WESTERN NUCLEAR, INC.

**SUBJECT: Response to November 18, 2003, Nuclear Regulatory Commission
Staff Letter Regarding Western Nuclear, Inc.'s Split Rock Uranium
Mill Site Final Site Closure Proposal, SUA-56**

TO: Larry Corte, WNI
FROM: Jan Johnson
DATE: February 12, 2004
SUBJECT: Response to NRC Letter – Item 3

TO: Larry Corte, WNI
FROM: Lou Miller, P.E.
DATE: February 12, 2004
SUBJECT: Response to NRC Letter – Item 4

**FIGURE 1
EXISTING AND PROPOSED
MONITORING WELLS**

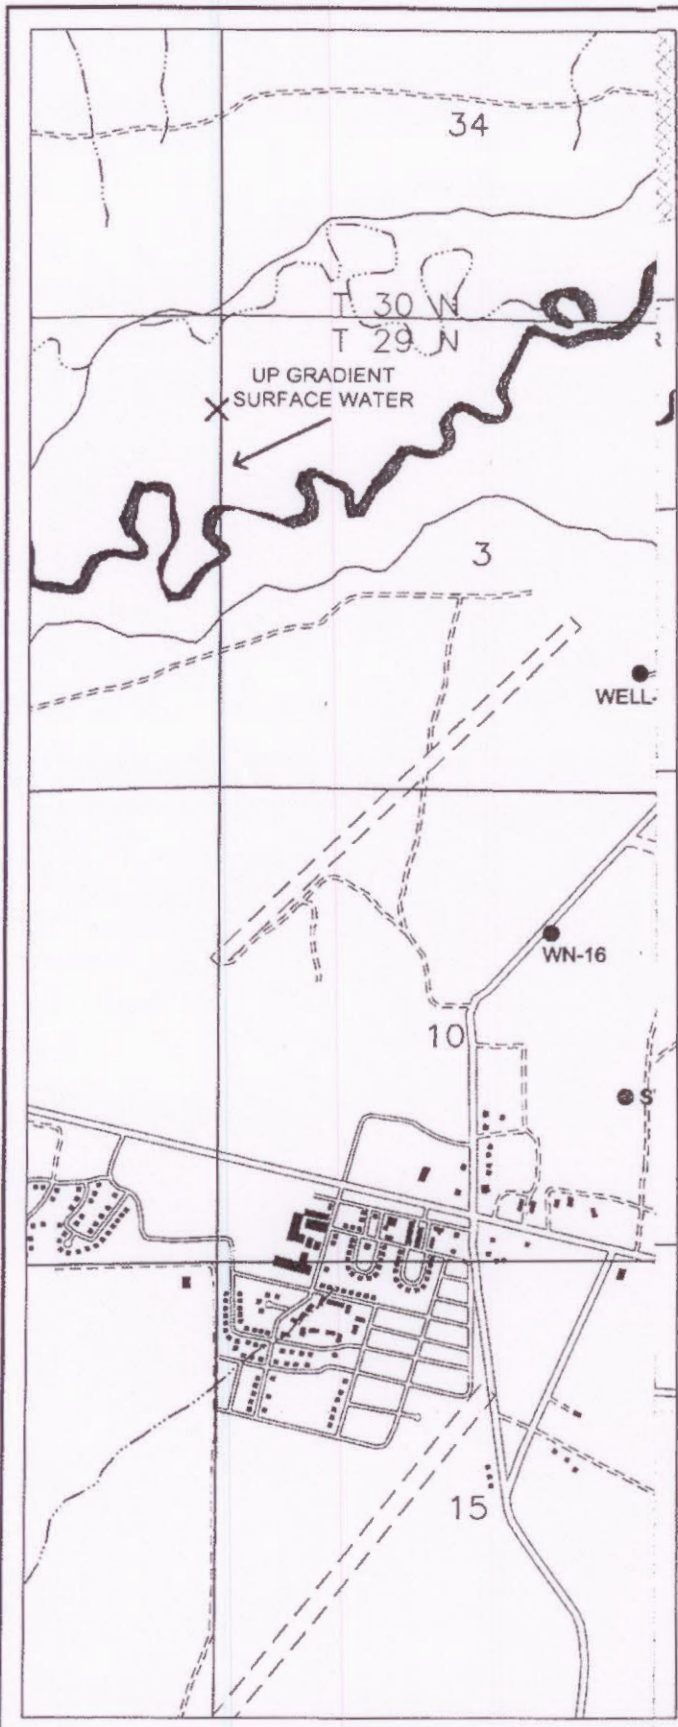
-
4. *In NRC's RAI, dated September 6, 2001, item number 2 requested that WNI address the deficiency of a long-term groundwater and surface water monitoring program. WNI's response of May 28, 2002, on this item is not adequate. William von Till discussed this issue in detail with Lou Miller in a phone conversation on November 4, 2003. This is also covered in the NRC Guidance document NUREG-1620, Section 4.3.3.4.*

A new groundwater and surface water monitoring program is proposed. This system is designed to better monitor evolution of the groundwater plume and to provide more detail for the surface water monitoring program. The location of the existing monitoring locations and the new proposed locations are shown on Figure 1.

The wells that are part of the existing monitoring requirements are generally close to the tailings impoundment and are not useful in defining the continued evolution of the contaminant plume. The new proposed wells will be able to monitor the plume as it matures. Data from the proposed wells could be used to evaluate the plume development with the modeled results.

Point of compliance (POC) wells, proposed in the October 1999 groundwater report (SMI, 1999), are Well 5 and Well WN-21. The proposal for these wells to be the POC wells remains the same.

Two new points have been added to the surface water sampling system. These points are labeled Surface water B and C. They supplement the existing sample location A to better monitor water in the Sweetwater River that might be impacted from the contaminate plume.
